CONTRACT CHANGE ORDER NO. _____
SHEET ___ OF ___

MARK	DATE	DESCRIPTIONS	BY	CH'D	CCO#
2	04/08/11	SUSPENSION CABLE MISCELLANEOUS DETAILS	GB	MN	185
1	01/28/11	MISCELLANEOUS CABLE SYSTEM DETAILS	GB	MN	37S1

SAN FRANCISCO OAKLAND BAY BRIDGE
EAST SPAN SEISMIC SAFETY PROJECT
SELF-ANCHORED SUSPENSION BRIDGE
(SUPERSTRUCTURE & TOWER)
EAST CABLE ANCHORAGE "E" LINE LAYOUT NO. 2

SUSPENDER SOCKET TYPE 1 (see Table)
1:2.5

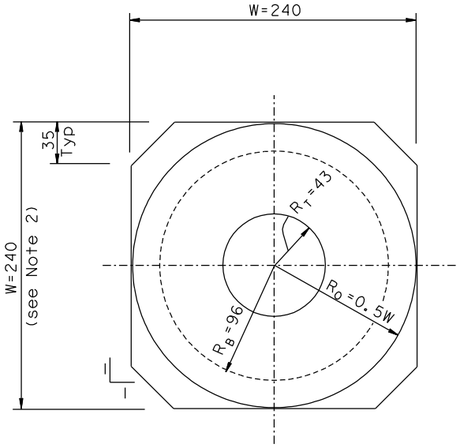
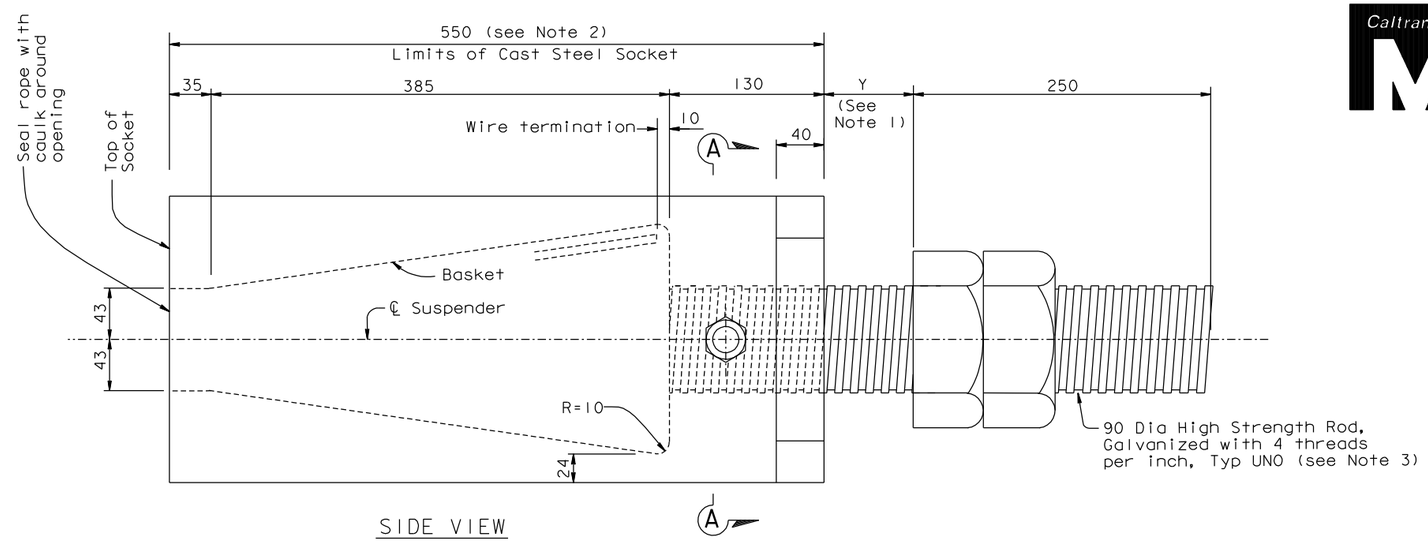
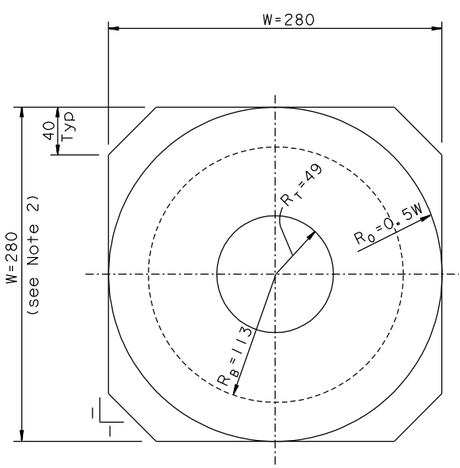
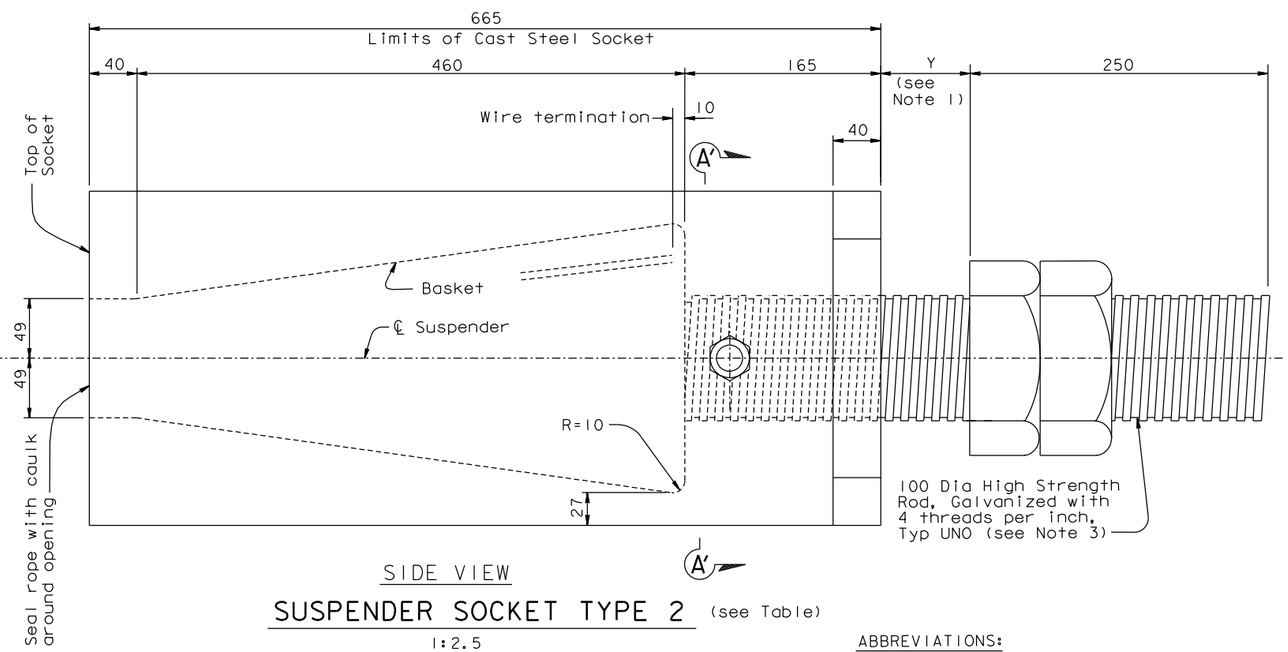
1. For dimension Y, see "Suspender Bracket Details No.3" sheet.
2. All suspender socket dimensions are for information only. The Contractor shall develop socket details consistent with his means and methods and the suspender bracket geometry, and shall submit them to the Engineer for review and approval. The socket dimensions shall be such that adequate prestressing and erection clearance is provided.

For alternate suspender socket, see "Suspender Socket Details (Alternate)" sheet.
3. For suspender socket anchor rod material, see "General Notes" sheets.
4. Rope sizes given for information only. For rope size, see "Suspender Layout No.1" sheet.
5. Loctite Blue 243 or an equivalent thread locking compound as approved by the Engineer shall be applied to the set screw. The thread locking compound shall be applied in accordance with the manufacturer's recommendations. (2)

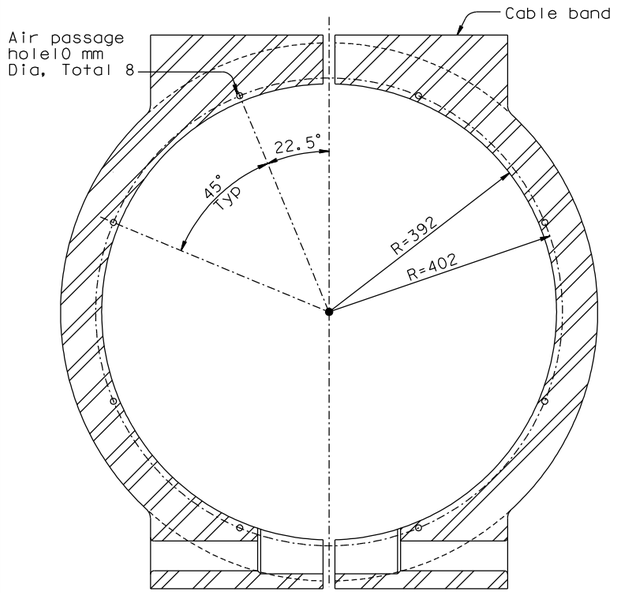
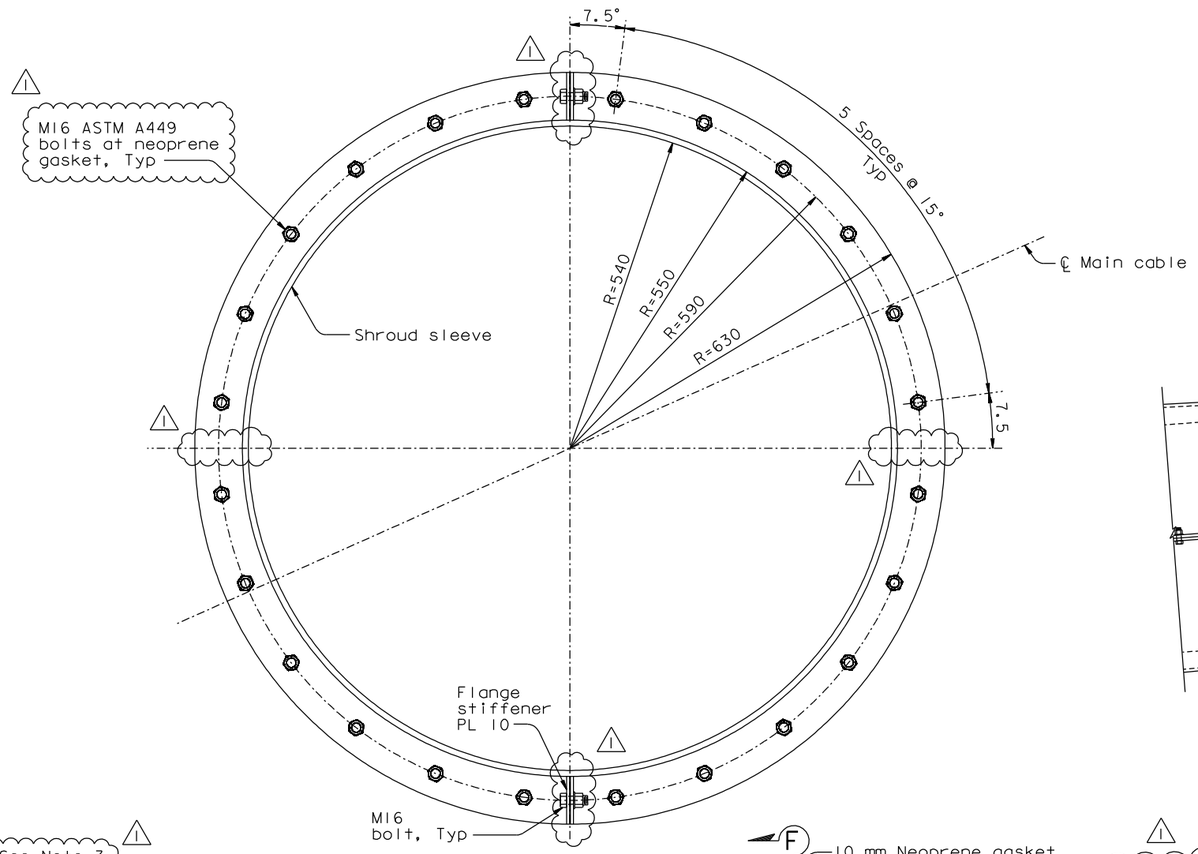
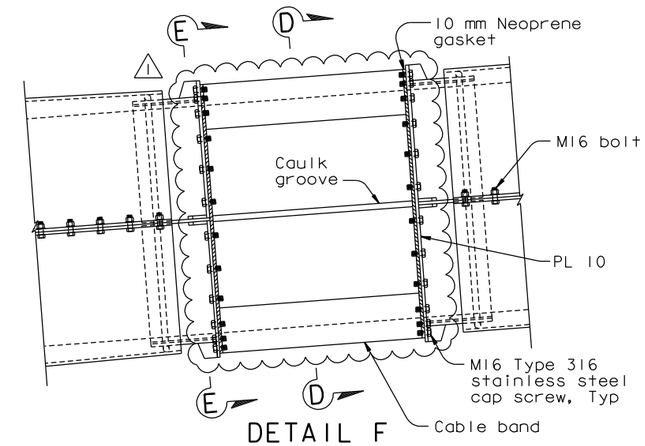
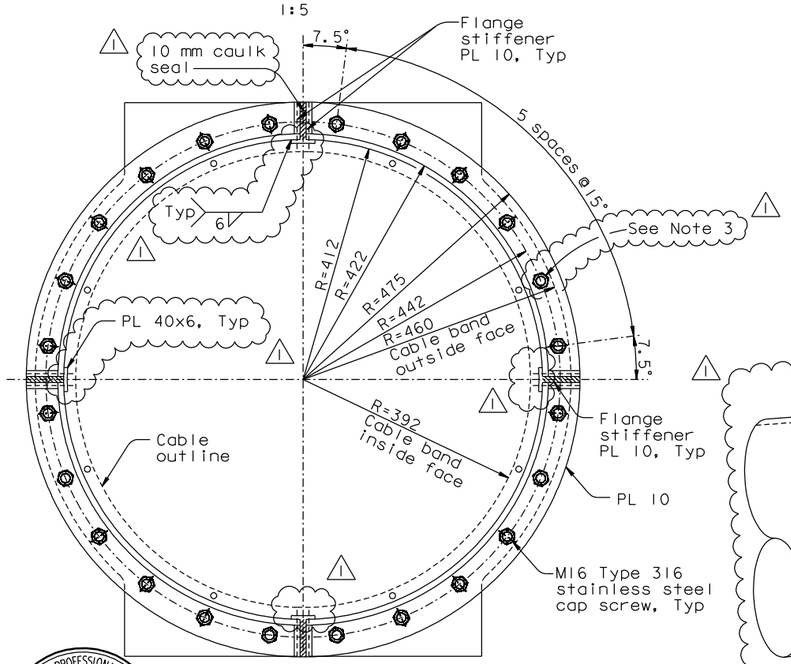
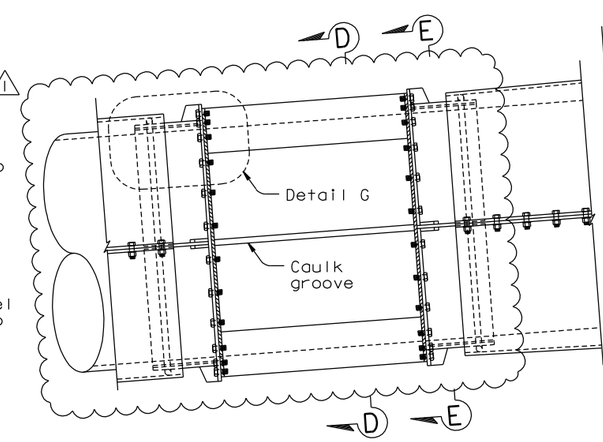
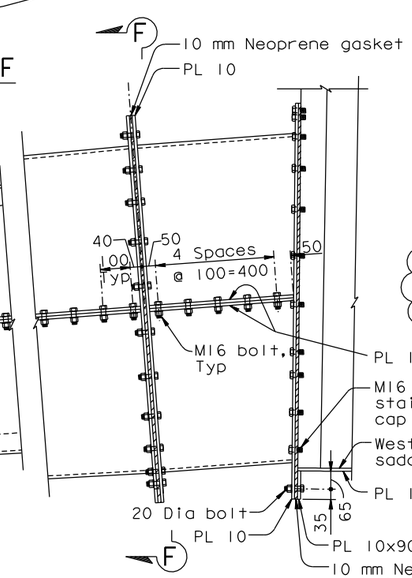
1. For additional details, see "West Cable Shroud Details No.1" sheet.
2. For cable band details, see "Cable Band Details" sheet.
3. At the Contractor's option, the cable shroud holes may be 22 Dia.

EAST CABLE SHROUD - PLAN
1:25

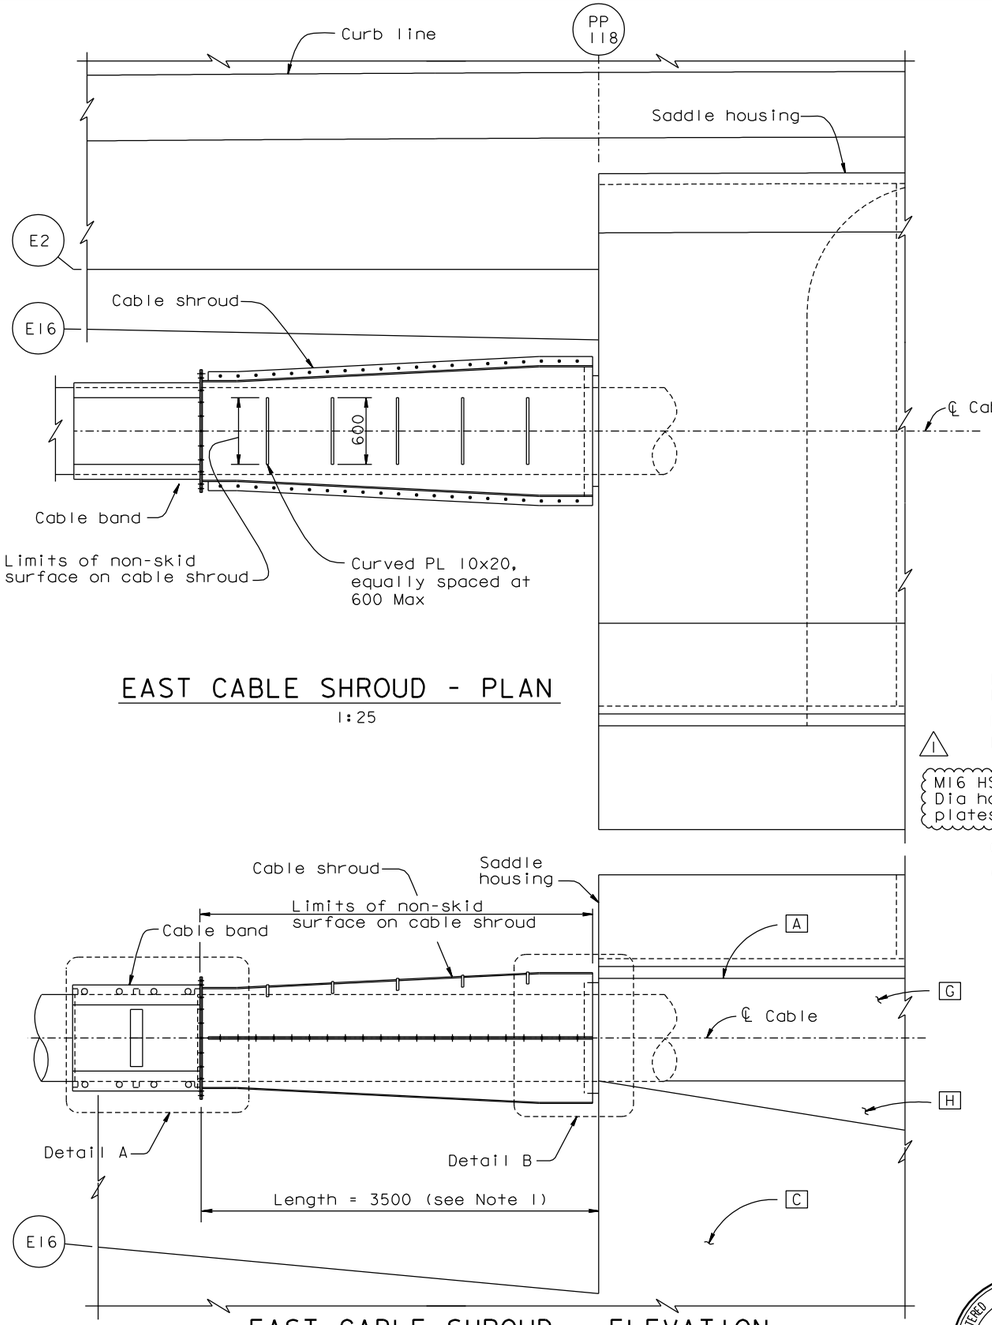
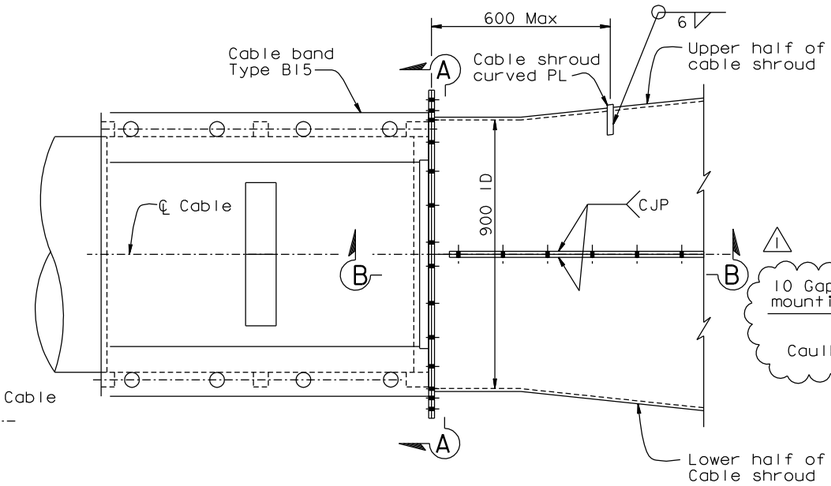
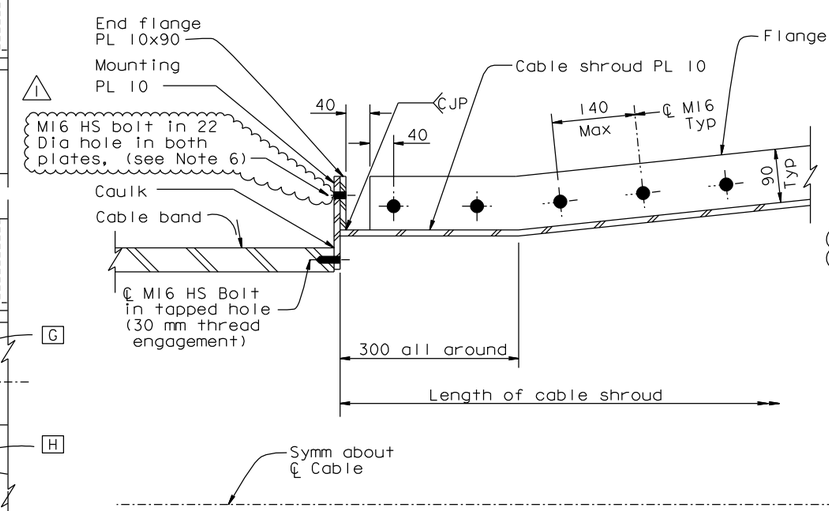
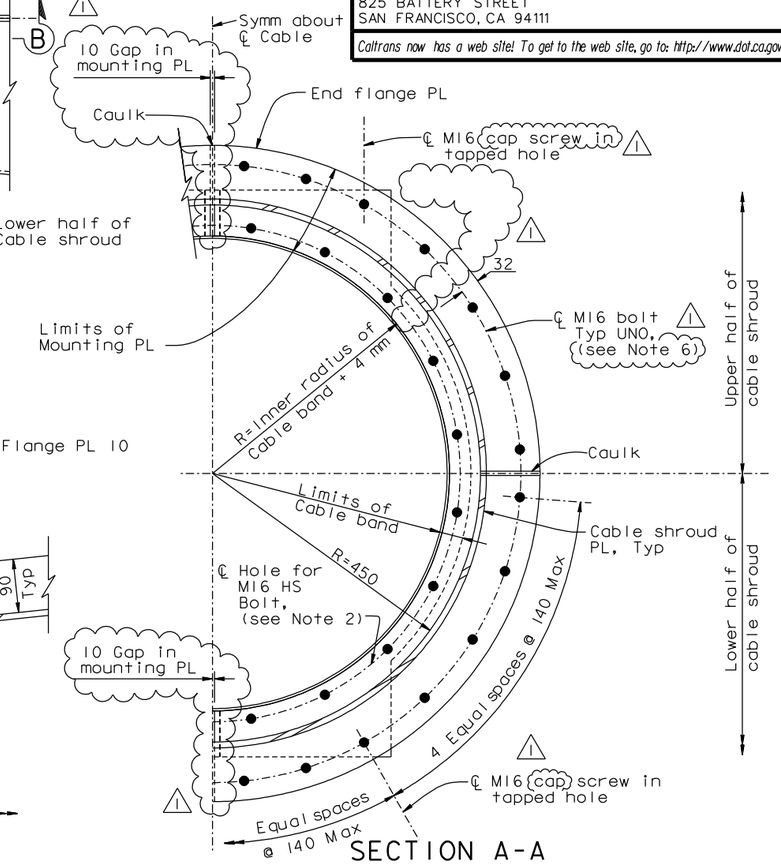
1. Dimension shown for cable shroud length applies to east anchorage locations only. Cable shroud length varies at all other locations.
2. Cable band bolts shall be tightened prior to installing mounting PL. Mounting plate holes may be 22 Dia. 1
3. For saddle housing, see "East Saddle Housing Details" sheets.
4. For cable band details, see "Cable Band Details" sheets.
5. For Detail B, see "East Cable Shroud Details No. 2" sheet.
6. M16 HS bolt in 22 Dia holes shall have 40 ODx6 mm plate washers under both head and nut. 1
